Product Change Notification

106415 - 00

Change Notification #: 106415 - 00
Change Title: S5000PAL, SR1500AL, SR2500AL, PCN
106415-00, Product Material, Class 1: System
Software Updates; Thermal Sensor
Reliability
Date of Publication: June 13, 2006

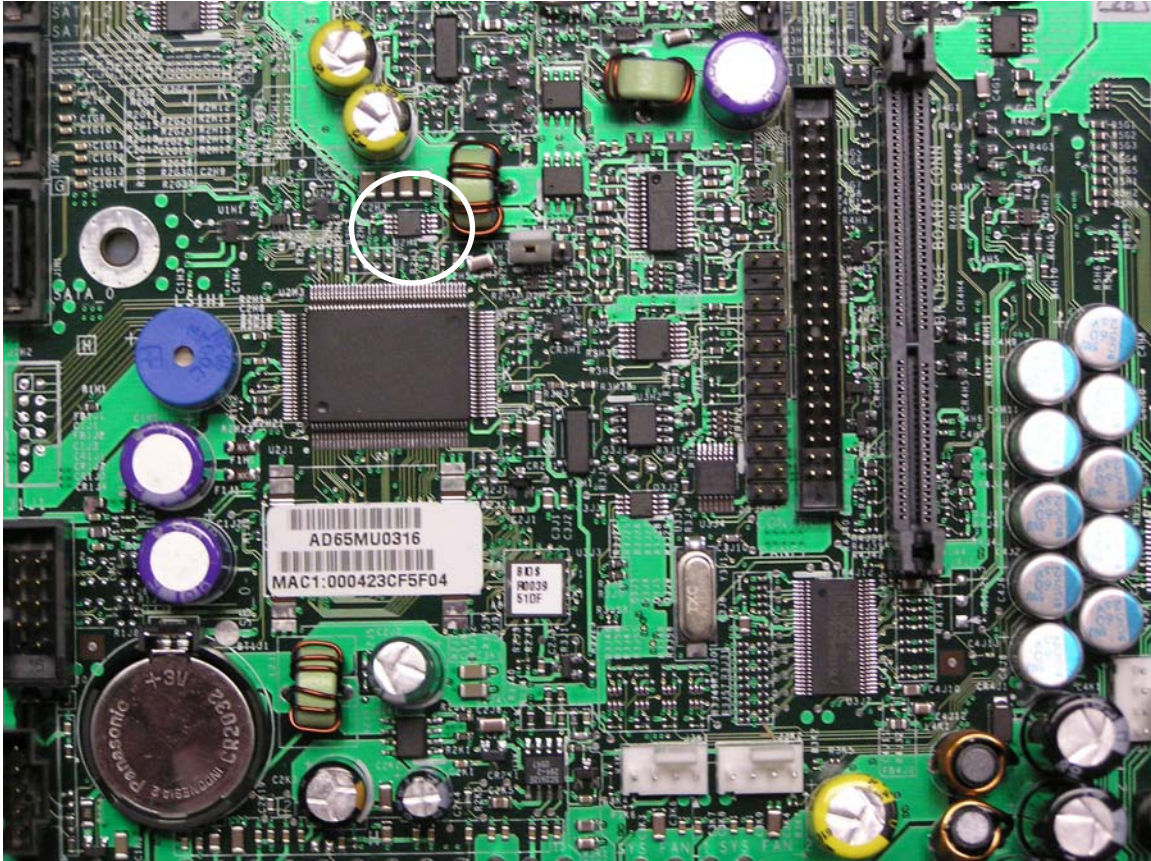
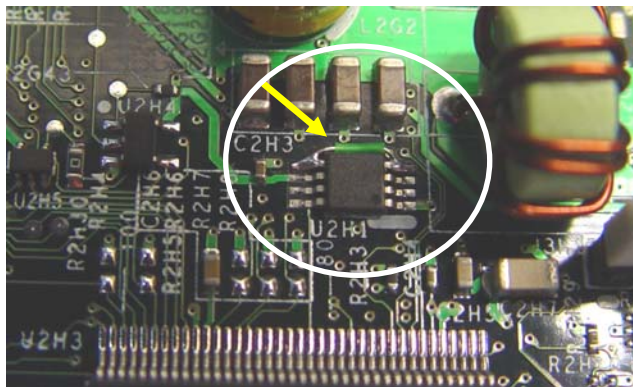
Change 2) A wire is being added to the baseboard to increase reliability of the baseboard thermal sensor (BB TEMP Sensor #30). The wire will run between pin #4 and Pin #5 of the thermal sensor component at location U2H1.

This change addresses possible false thermal readings which could affect the fan control sub-system of a non-Intel chassis, or false thermal readings displayed by Server Management software.
